MEMORANDUM

Lindvest Properties (Cornell) Limited (SC. 12-115332)

Site Plan Application to permit 250 stacked townhouses south of Highway 7,

SITE PLAN

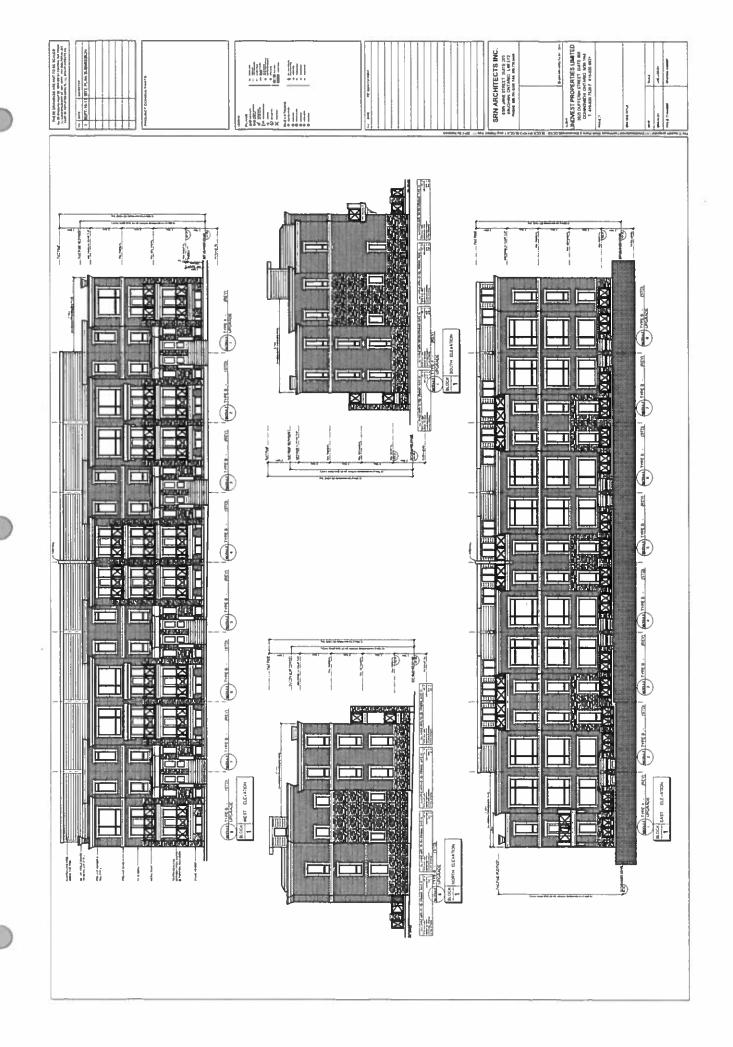
Outstanding site plan comments that need to be addressed prior to site plan endorsement Staff are generally satisfied with the site plan and elevations and are currently working with the applicant to finalize some aspects of the project. The following details will have to be finalized prior to issuance of site plan endorsement:

(a) Waste Management System must be revised

The waste management system proposed for this site is based on the system implemented at 318-326 John Street. This system has a number of garbage chutes outside at ground level that connect to waste recycling rooms located in the underground garage. Each chute and room will serve approximately 60 units and will be set up to accept garbage, recycling and organics. On pick up days, the bins will be moved up from the underground by the property management company to a common collection area. Based on the standard of one chute/60 units this site would require a minimum of 4 chutes to serve the 250 townhouse units. The site plan only shows 2 chutes/rooms at this time. Staff will continue to work with the applicant to confirm the waste management system for this project. Site plan endorsement will not be issued until the Waste Management Department has confirmed that they are satisfied with the waste system.

(b) Clearance from Region of York required

The Region of York Transportation Department has not issued an approval letter for this project. The applicant is in the process of revising their engineering drawings to address the Region's comments. Site plan endorsement will only be issued after staff have received a clearance letter from the Region of York.
